Prairie Island Nuclear Generating Plant
1717 Wakonade Drive East
Welch, MN 55089

License Amendment Request to Adopt NFPA 805 Performance-Based Standard for Fire Protection for Light Water Reactors – Response to Request for Additional Information – 90-Day Responses (TAC Nos. ME9734 and ME9735)

Response to Requests for Additional Information (RAIs)
Regarding the License Amendment Request to
Adopt National Fire Protection Association (NFPA) Standard 805
at Prairie Island Nuclear Generating Plant Units 1 and 2

Figure F-1 PINGP Main Control Room

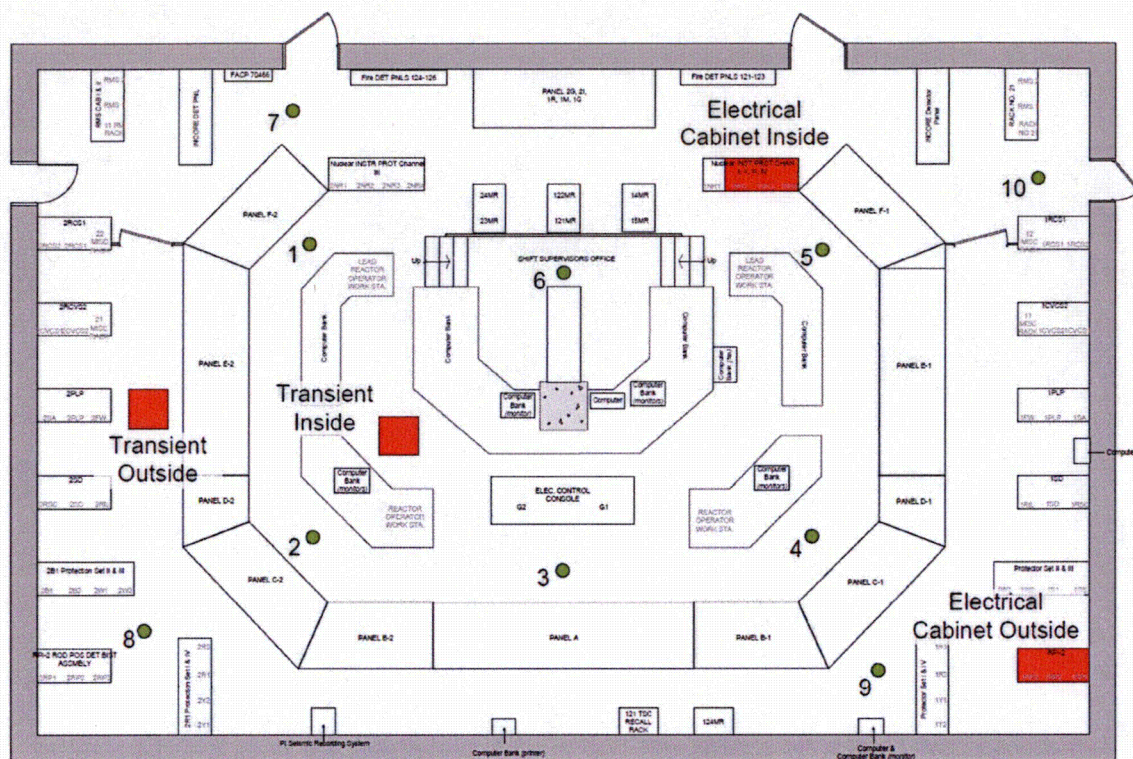
NSPM Response (FM RAI 01.w):

The four simulated (i.e. selected) fire locations were spread out to reasonably depict a fire scenario anywhere in the MCR. These four different fire locations, which are evaluated with both transient and electrical cabinet heat release rate profiles, were placed inside and outside the MCR horseshoe in the Fire Dynamics Simulator (FDS) analysis to simulate potential fires in the MCR. Transients were placed on the floor spaced evenly between adjacent electrical cabinets to ensure that combustion products migrate unobstructed into the hot gas layer. One electrical cabinet fire was placed along the wall in order to capture "wall effects" in the fire generated conditions since a number of panels in the MCR have wall configurations.

Figure F-1 illustrates the simulated fire locations (transient inside, transient outside, electrical cabinet inside and electrical cabinet outside) in the MCR:

Figure P12-1 – Alternate Shutdown Top Logic

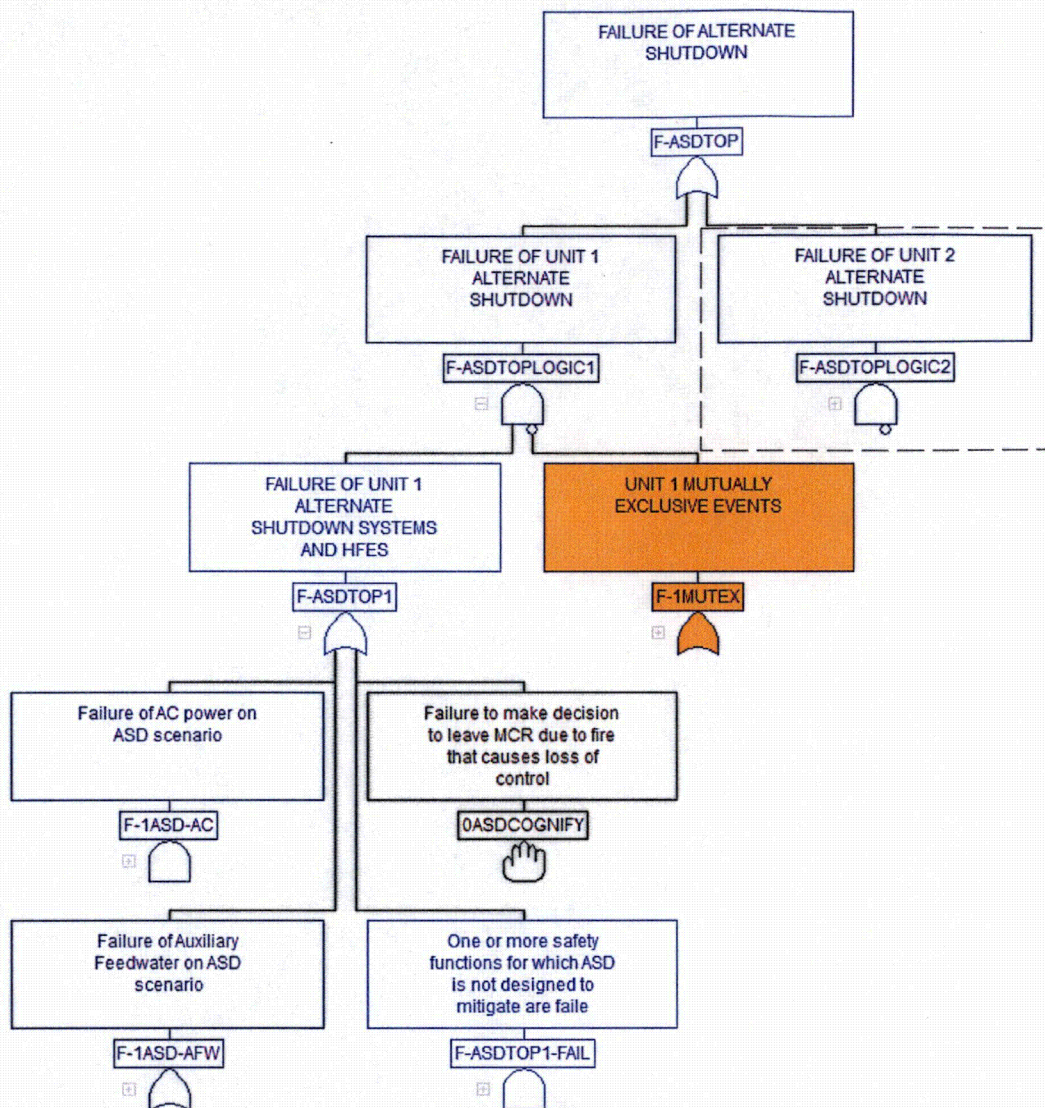
- b. Please explain how the CCDPs/CLERPs are estimated for fires that lead to abandonment due to loss of habitability and how they address various possible fire-induced failures. Specifically include in this explanation, a discussion of how the following scenarios are addressed:*
- (i) Scenarios where fire fails only a few functions aside from forcing MCR abandonment and successful alternate shutdown is straightforward;*

The alternate shutdown model was developed to be applied directly into the Fire PRA model. By turning on the "F-ASD" flag, the logic associated with Alternate Shutdown is activated when the model is solved. Fault tree gates from the balance of the Fire PRA model were also used in the fire alternate shutdown model to include hardware failures which could contribute to failure to complete alternate shutdown procedures.

The Alternate Shutdown top logic fault tree is shown in Figure P12-1, below. Although the figure shows the F-ASDTOP as a top gate, this was done for ease of use. Each of the second tier gates, F-ASDTOPLOGIC1 and F-ASDTOPLOGIC, are also inputs into the CDF gates for quantification.

The logic for Alternate Shutdown for each Unit consists of three gates and a basic event, 0ASDCOGNIFY. [Note: 0ASDCOGNIFY is the HFE modeled for the Shift Supervisor failing to make the decision to abandon the MCR for fires that could cause a loss of control; this is discussed further under the response to item d (ii)]. The gates for Unit 1 are detailed below; however, the equivalent gates are also present for Unit 2:

Figure P16-1 Incipient Detection Fault Tree

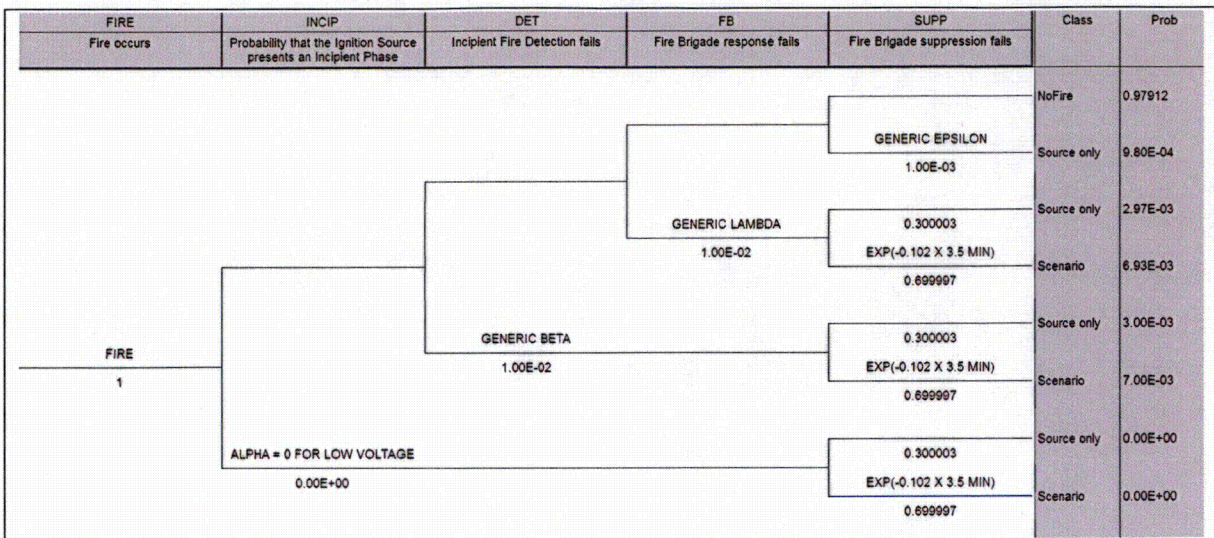
Please describe the treatment of sensitive electronics for the FPRA, and explain whether it is consistent with the guidance in FAQ 13-0004, including the caveats about configurations that can invalidate the approach (i.e., sensitive electronic mounted on the surface of cabinets and the presence of louvers or vents). If the approach is not consistent with FAQ 13-0004, justify the approach, or replace the current approach with an acceptable approach in the integrated analysis performed in response to PRA RAI 03.

The logic model has the following events (See Figure P16-1 below):

Branches following failure in the successful operator response or detector unavailability lead to prevention of damage to the targets by the fire brigade. The probability of "normal" non-suppression is calculated using the Detection Suppression Event Tree in NUREG/CR-6850, Appendix P, and the electrical fire suppression curve for manual suppression from Chapter 14 of NUREG/CR-6850 Supplement 1. Credit should be given as described in Appendix P for automatic detection and suppression (normal spot detectors and automatic suppression in the area) as well as delayed manual detection, manual actuation of fixed suppression, and manual suppression via the fire brigade. In this application, a conservative time of 3.5 minutes has been selected for calculating an approximate branch probability of 30% success suppression by the fire brigade. The 3.5 minute value is a representative conservative value applied to all the scenarios. It is the estimated time it takes the flames of a fire postulated outside an electrical cabinet to reach the cable damage temperature of approximately 205°C , assuming a fire growth to a peak of 1 MW in 12 minutes (fire growth rate recommended in Appendix G of NUREG/CR-6850). Recall that the brigade response time is not considered when the suppression curves from Chapter 14 of NUREG/CR-6850 Supplement 1 are used. The value is considered conservative as all the cabinets in the fire compartments where the system is credited are closed.

Results: The multiplicative factor to the ignition frequency is the sum of the resulting branch probabilities with the exception of the top branch (No-Fire). This resulting sum is $9.8E-4 + 2.97E-3 + 6.93E-3 + 3.0E-3 + 7.0E-3 = 0.02088 \approx 0.02$.
